CONSTRUCTION DOCUMENTS FOR:
HAVEN VALLEY
 (LETA DR.) BRADLEY RD/ALTURAS DR.
 SECURITY, EL PASO COUNTY, COLORADO

v1_Construction Drawings.pdf Markup Summary 10-19-2023

DEERHAVEN VIEW WATER & SAN. PLAN & PROFILE
 PROJECT NO. 21085-03CSCV
 DRAWING NO.

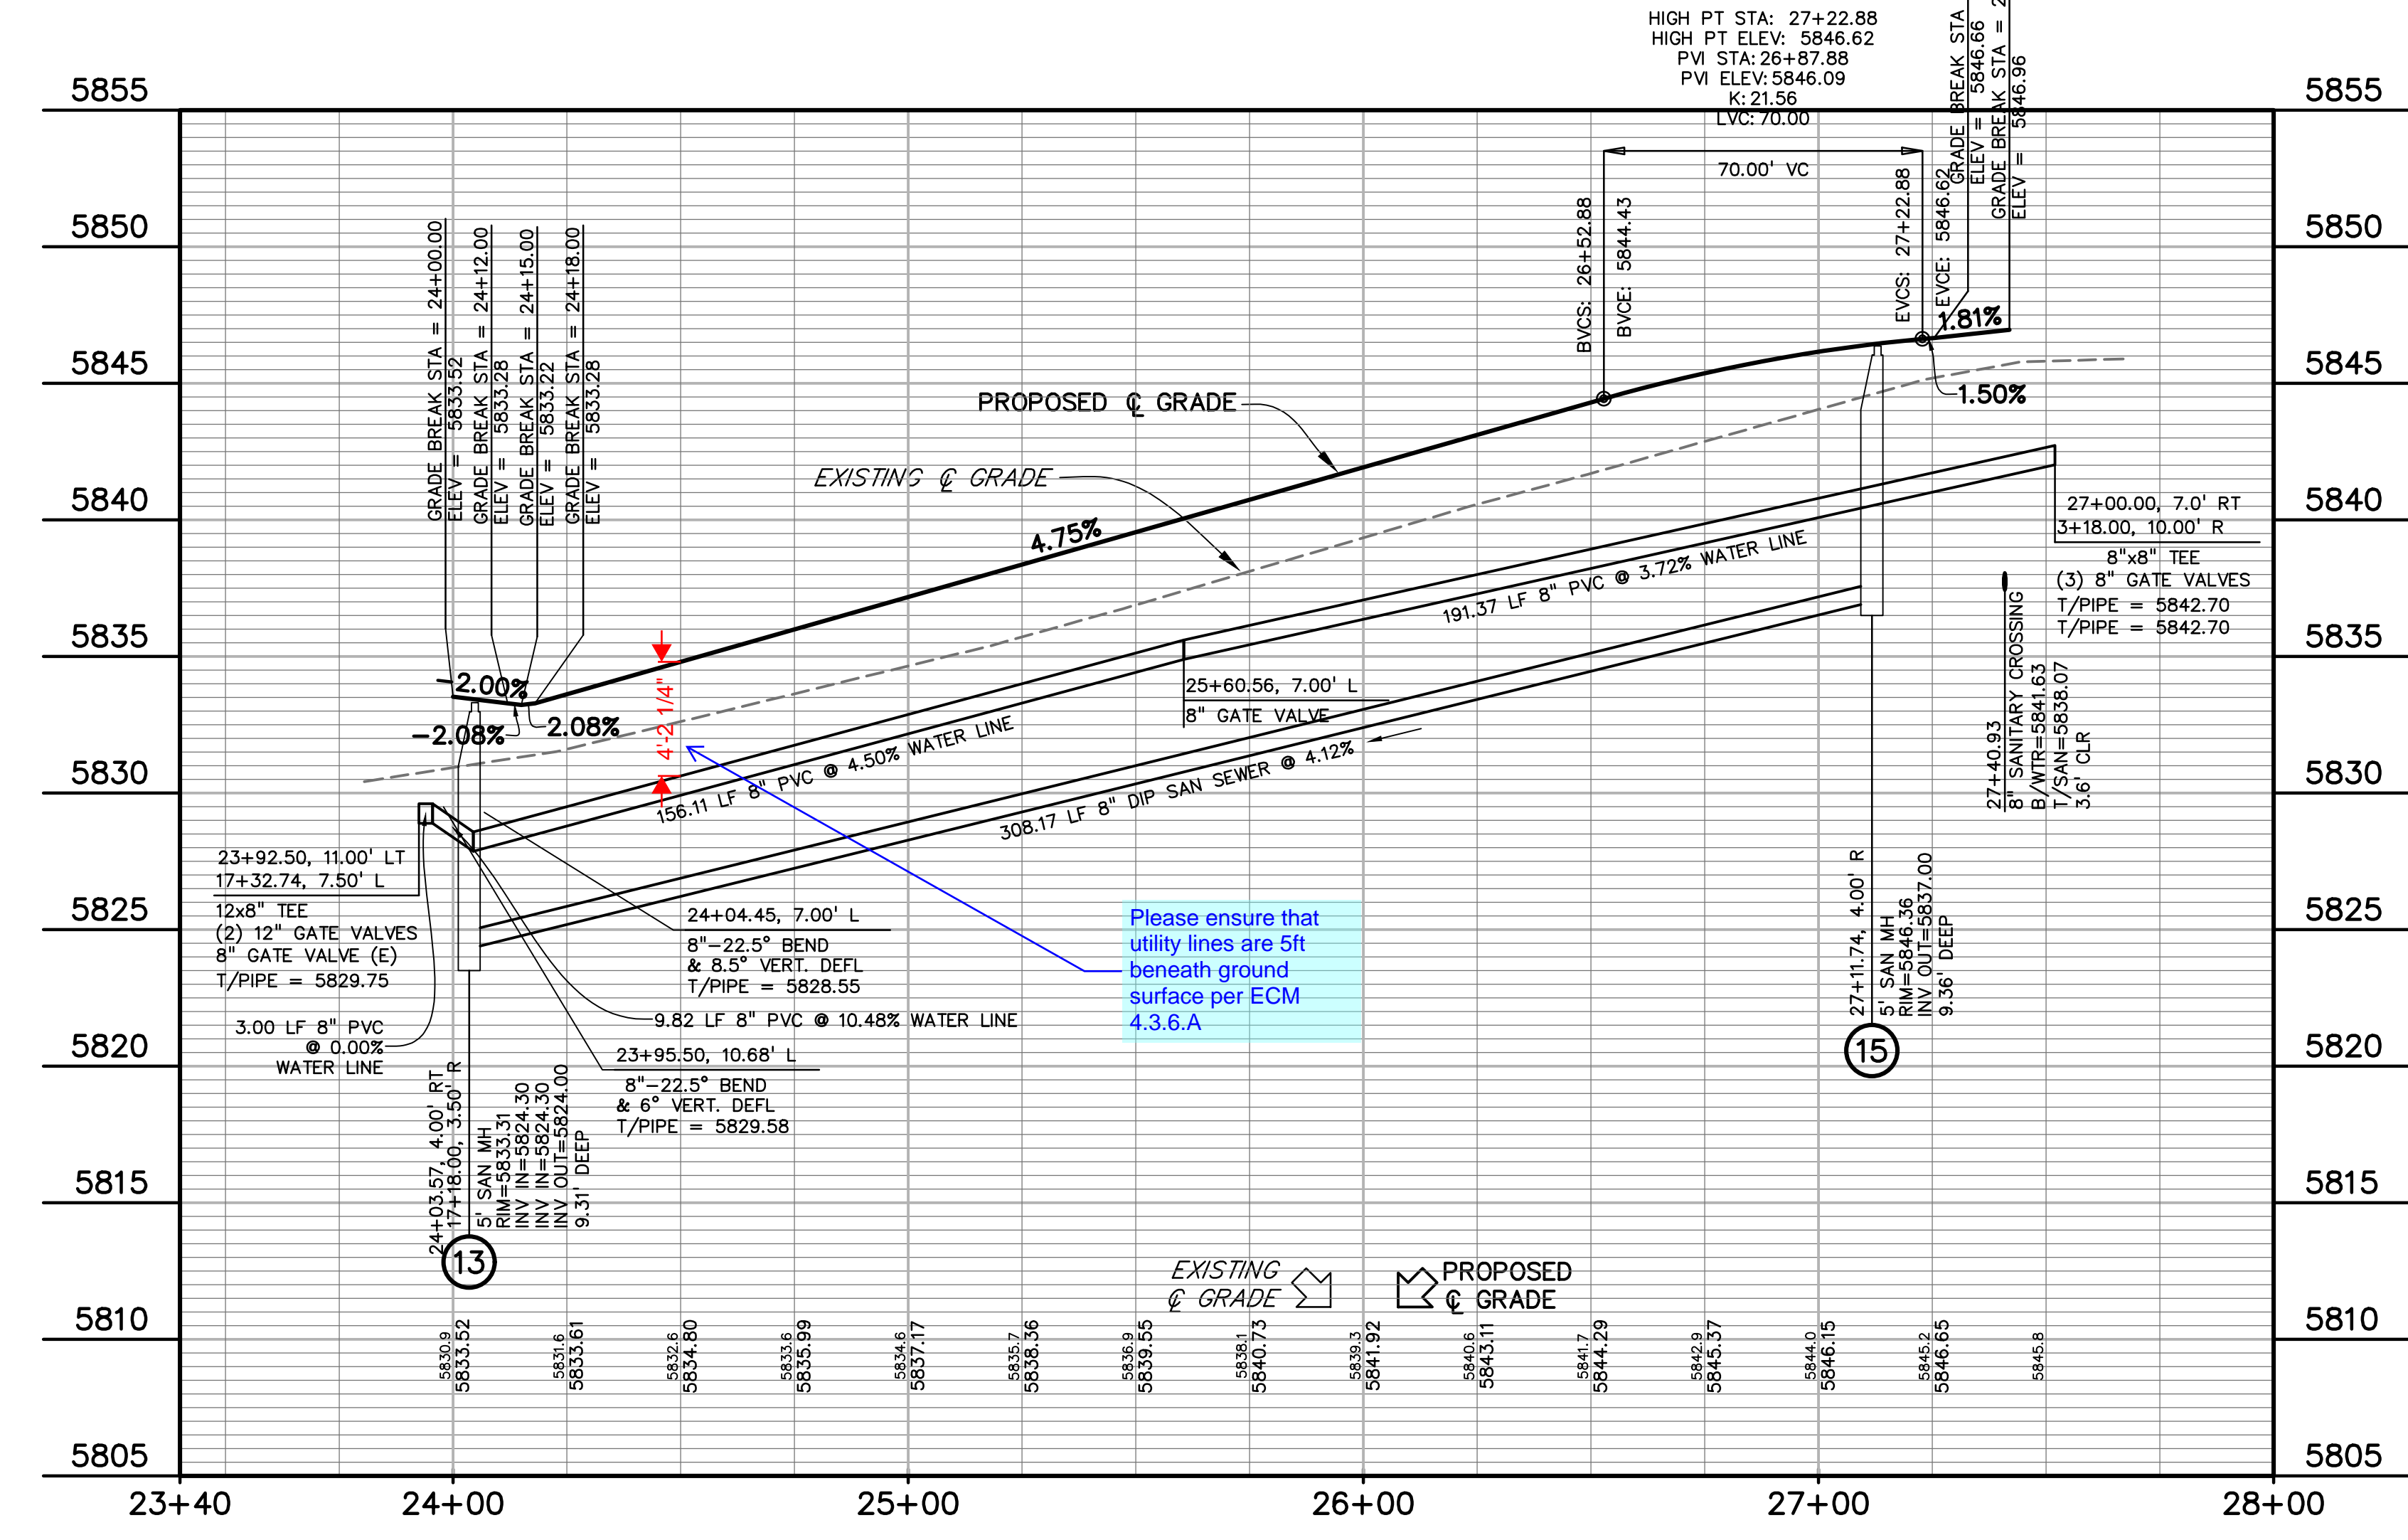
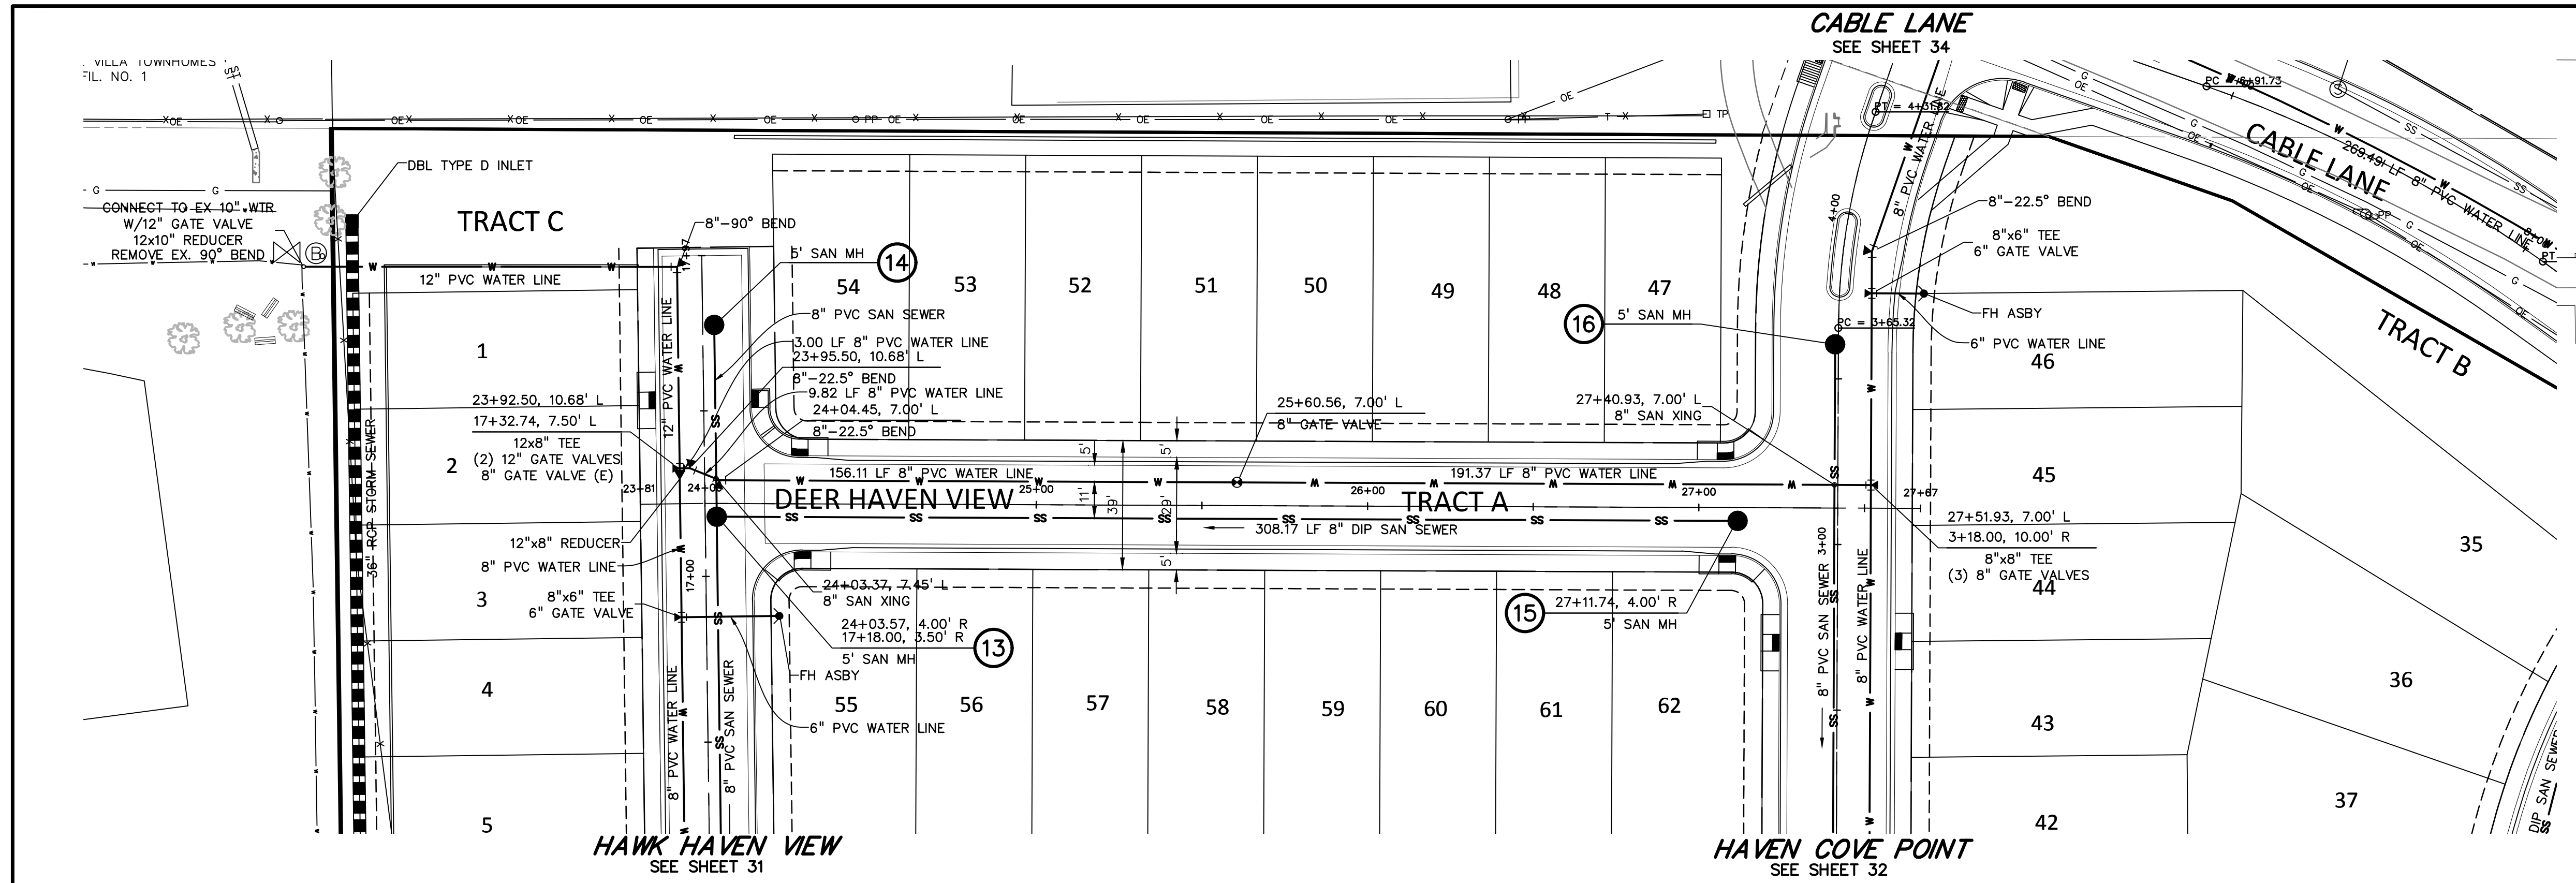
Please ensure that utility lines are 5ft beneath ground surface per ECM 4.3.6.A
